To: Rob Romero
From: Brian Chambers, Senior Planner; 910.342.2782
CC: File;
Date: 11/1/2022
Re: Mess Hall Parking Lot TRC Rev. 2

Project Name: **MESS HALL**

Formal TRC #2 Date: **10.18.2022**

Departure Sight Triangle for Viewing Traffic Approaching the Minor Road from the Right

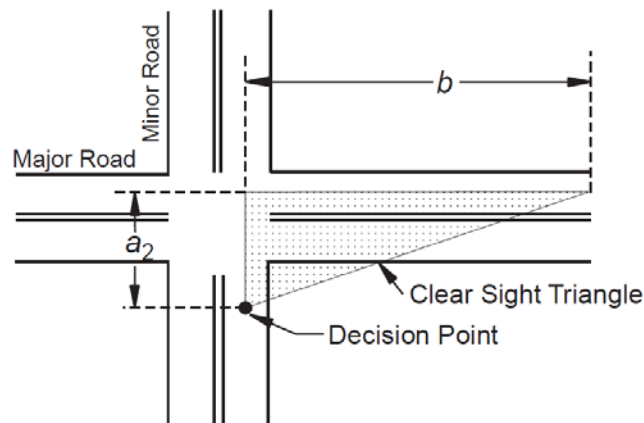
SIGHT DISTANCE TRIANGLE FOR ANY STREET/DRIVEWAY INTERSECTIONS WITH THOROUGHFARES

This section of Wrightsville Ave is a major thoroughfare [Chap VII (C) (2) (a) of CofW Tech Stds]. In accordance with the City Code, sight distances along thoroughfares must be calculated in compliance with the AASHTO requirements. [Chap VII (C) (1) of CofW Tech Stds] [Sec.18-556 CofW LDC] [Sec. 18-667 CofW Updated LDC]. Show AASHTO sight distance for traffic departing from Moss St. Below image is for reference only and sight clearance must be calculated based on speed and street configuration.

Refer 'AASHTO A Policy on Geometric Design of Highways and Streets', Chapter 9.5.2.2 Departure Sight Triangles.
